ADDENDUM #4 - CM CLARIFICATIONS

Hunger Solution Center
Additions & Renovations
August 21, 2025

ADDENDUM NO. 4
Date: August 20, 2025
TSSF Project # 2154

SHEET NO.
A7.0

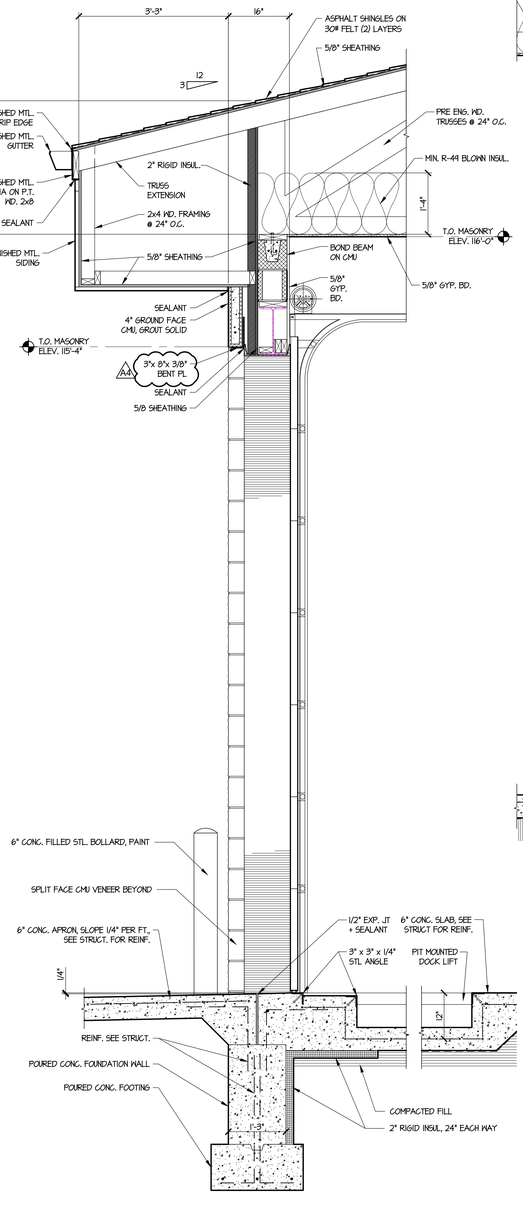
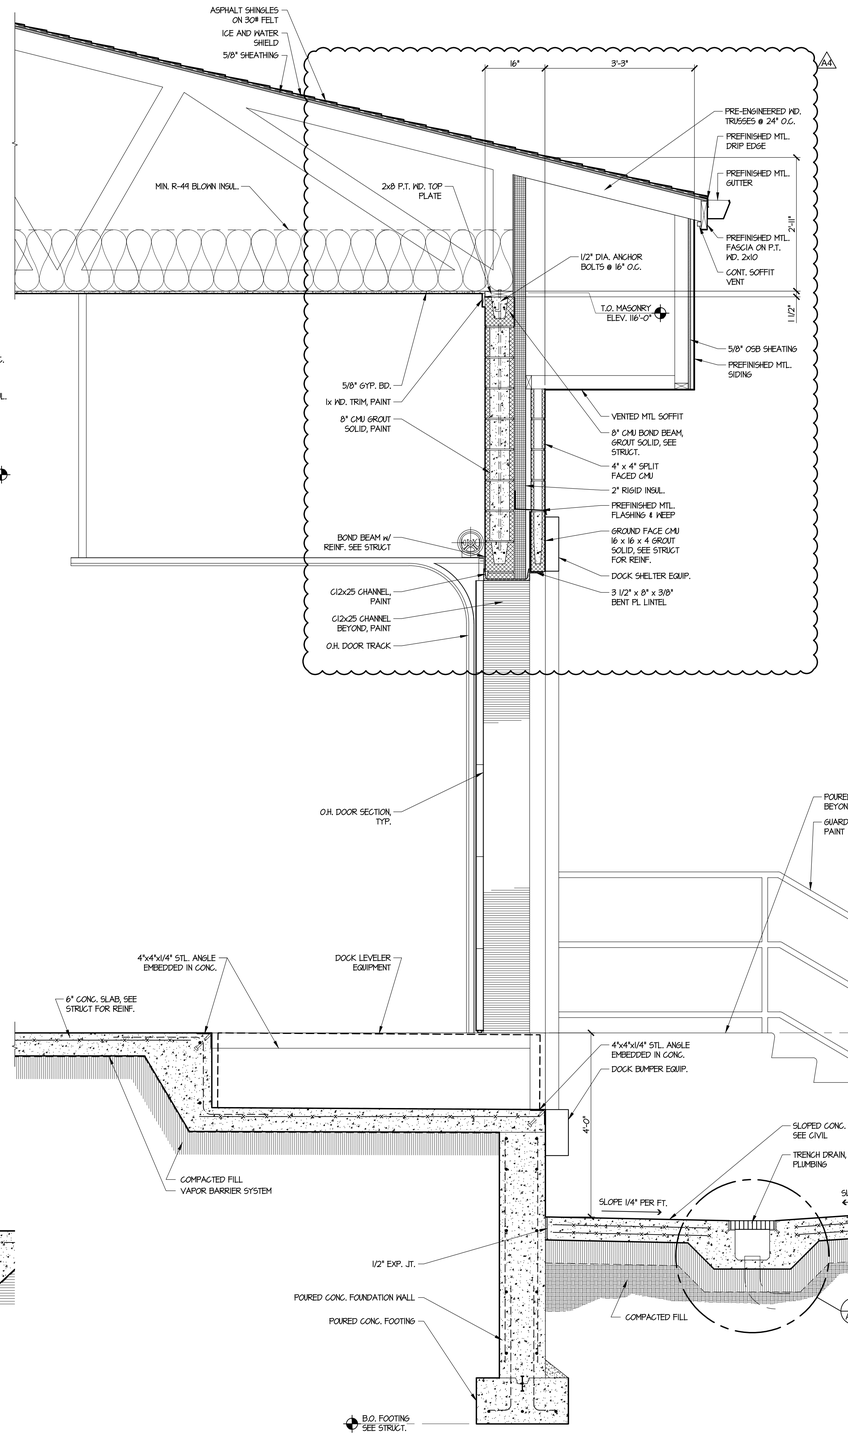
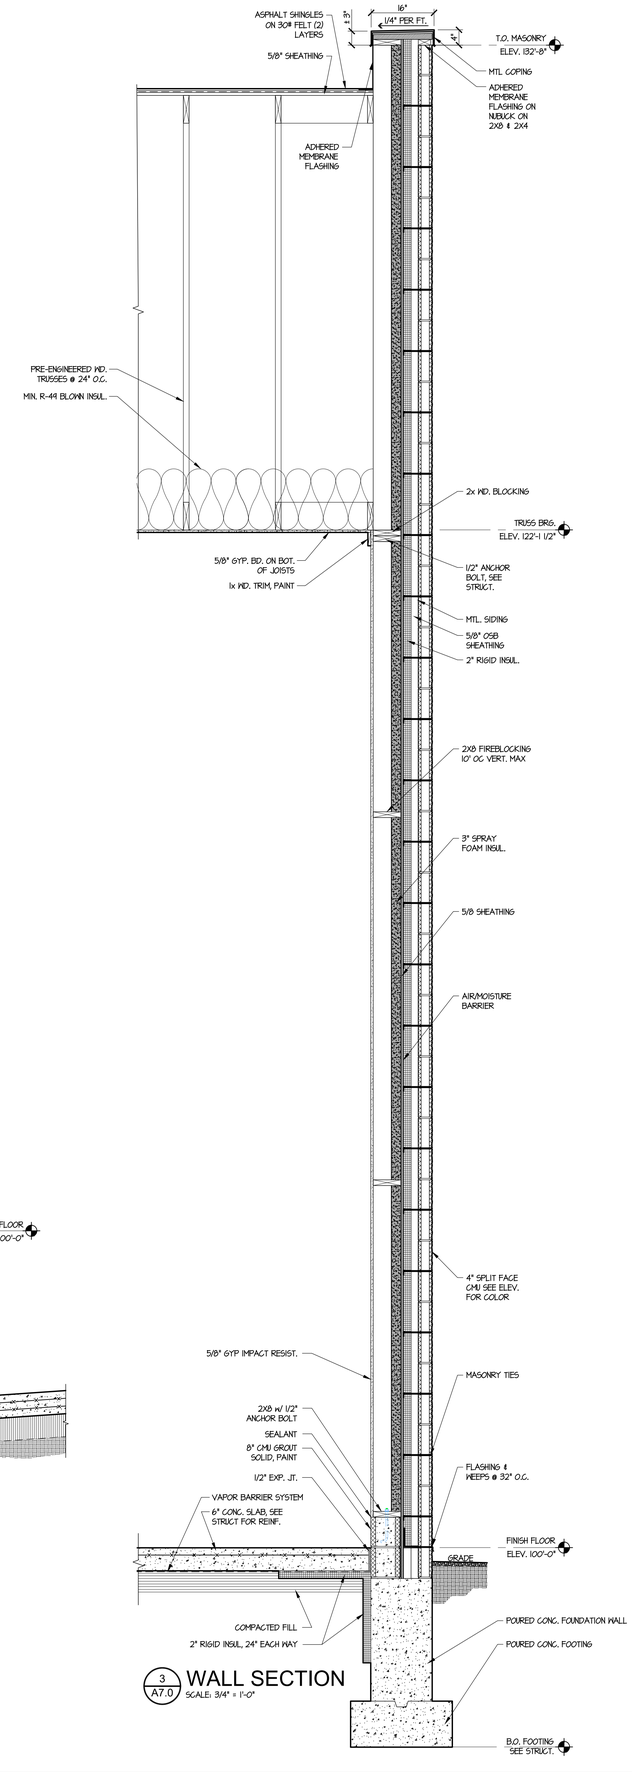
Item A8: **SheetA6.0, Sheet A7.0: Reissued:**
Section 1/A6.0 and 2/A7.0 have been revised to indicate the roof overhang and masonry above the overhead door.

SHEET NO.
S1.0

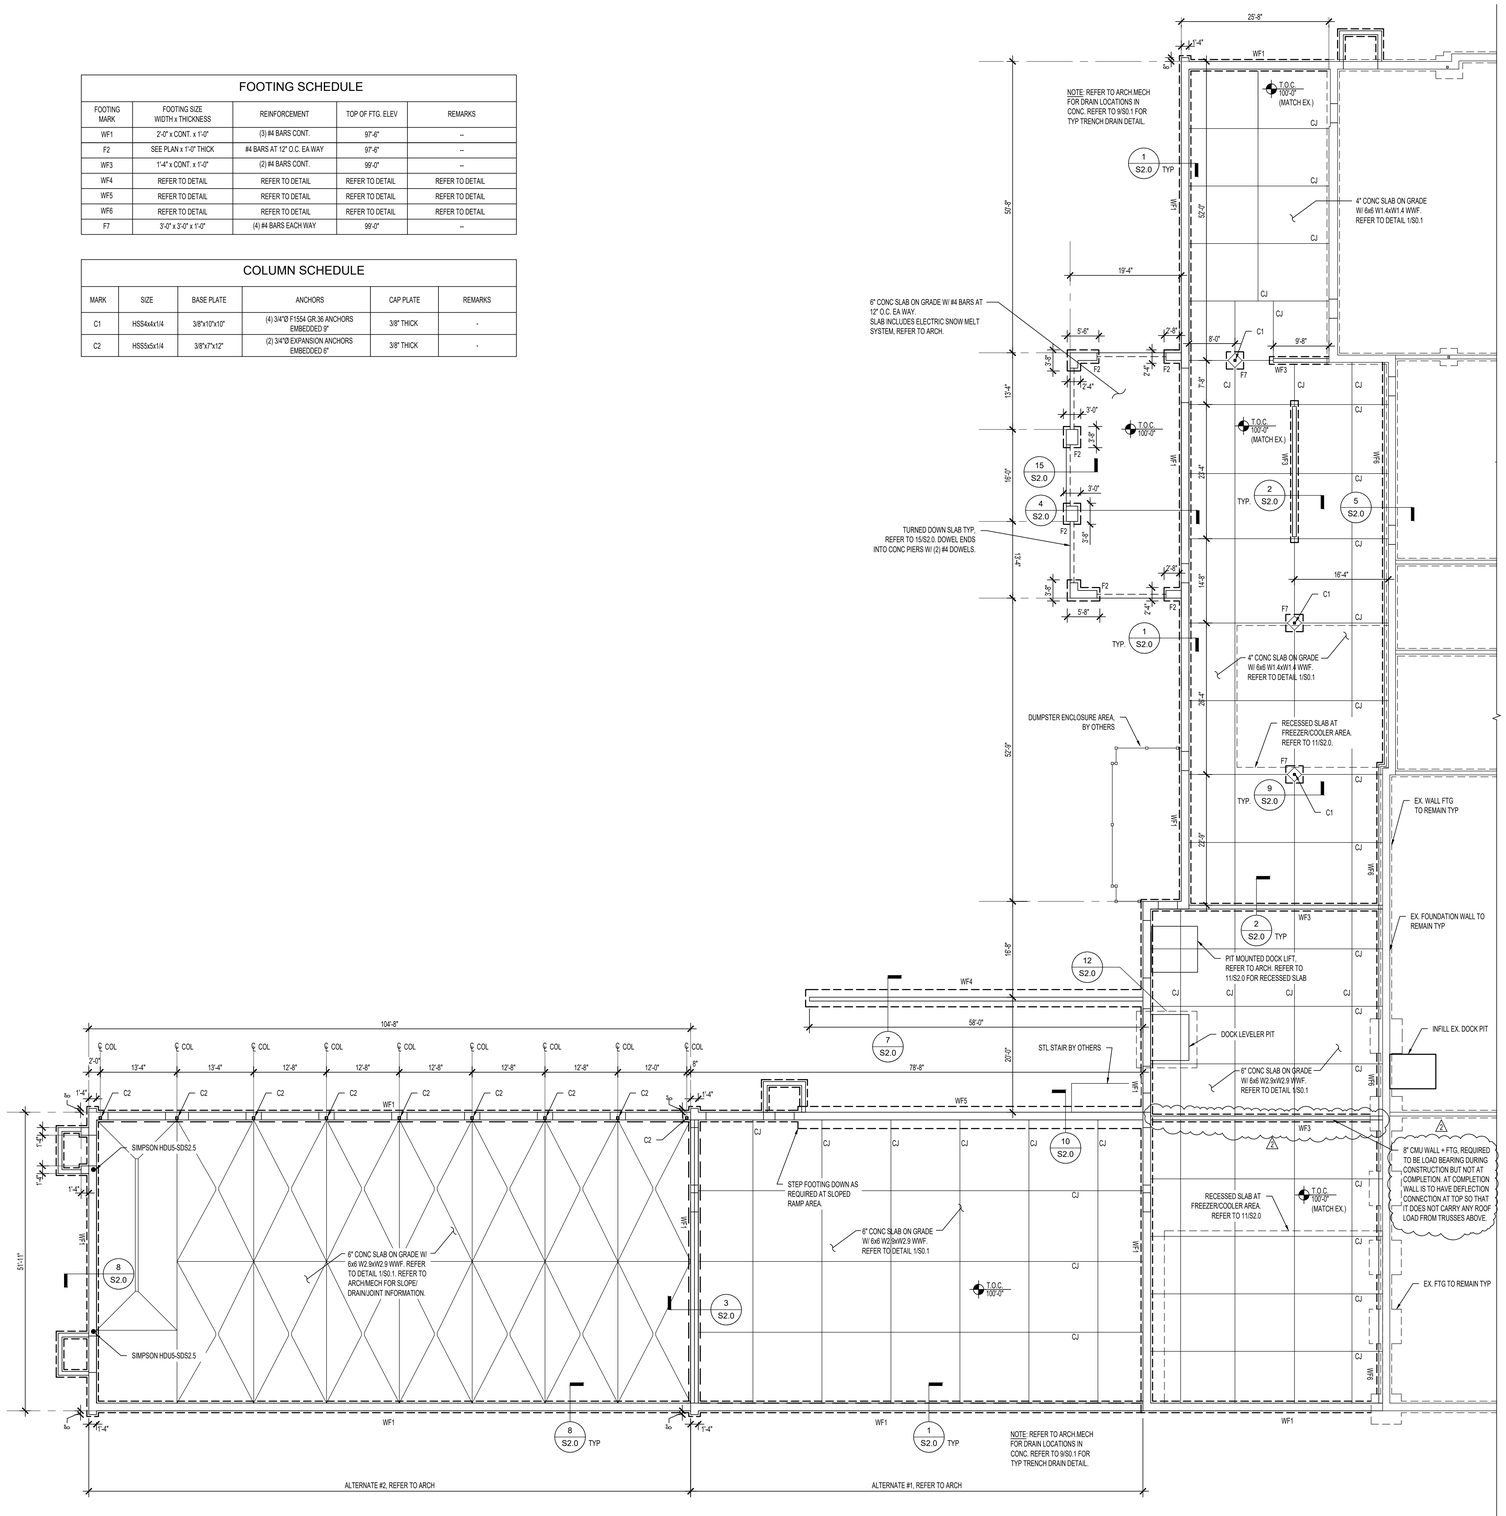
Item S1: **Sheet S1.0: Reissued:**
Sheet S1.0 has been reissued to indicate an additional foundation required for the Construction phasing in lieu of thickened slab.

DRAWN BY RLM
DATE 7/03/25
APPROVED JWF
SHEET NO. E2.2
PROJECT NO. 2154

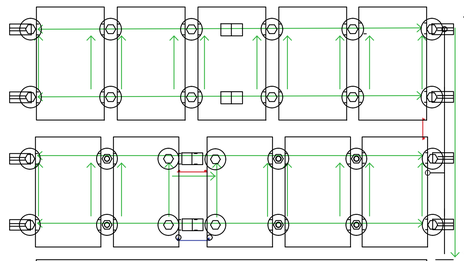
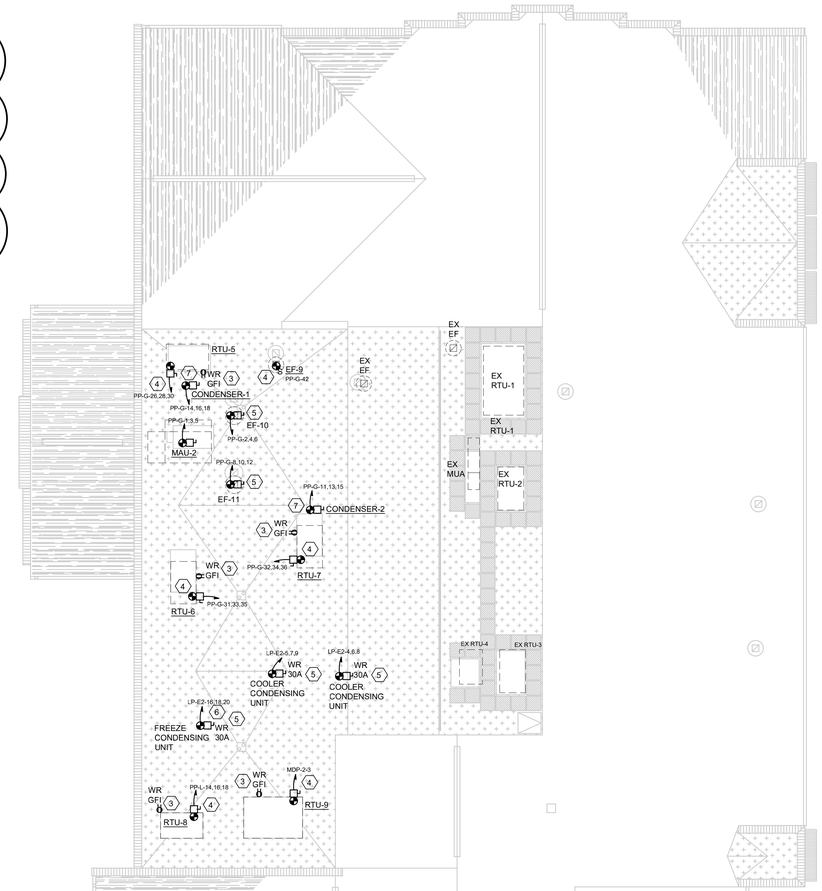
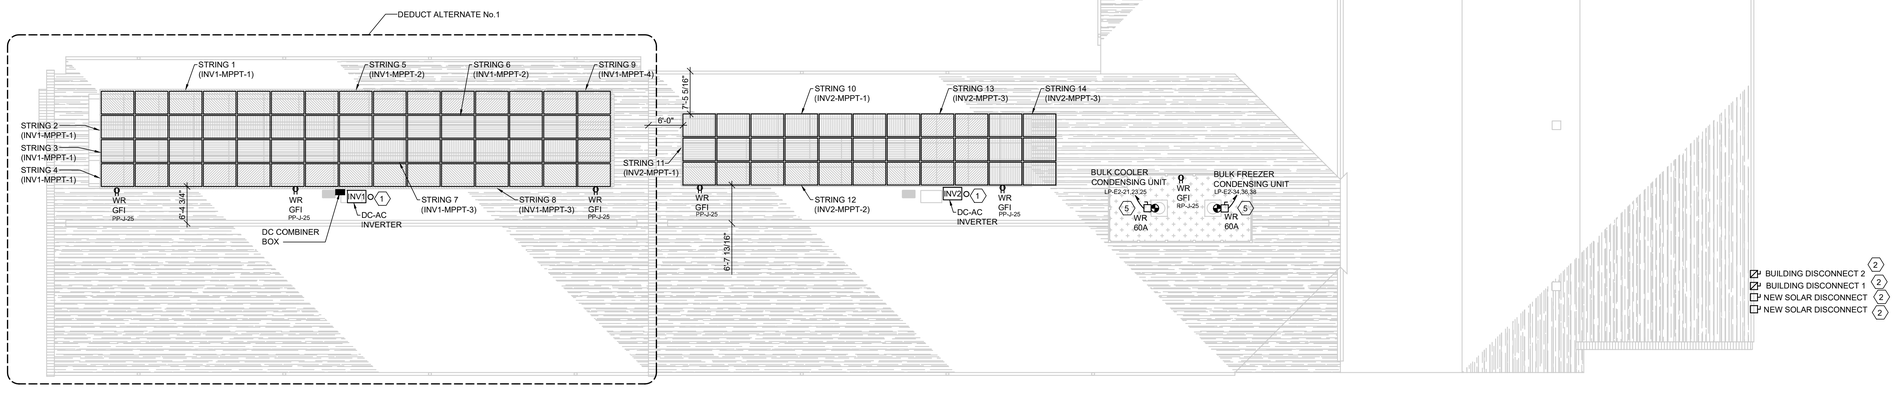
Item E1: Refer to sheet E2.2 (Re-issued)
Added solar general note #4 and PV mounting details – including roof mount site view, PV clamp details, PV rail splice details, and PV ground & bonding diagram.
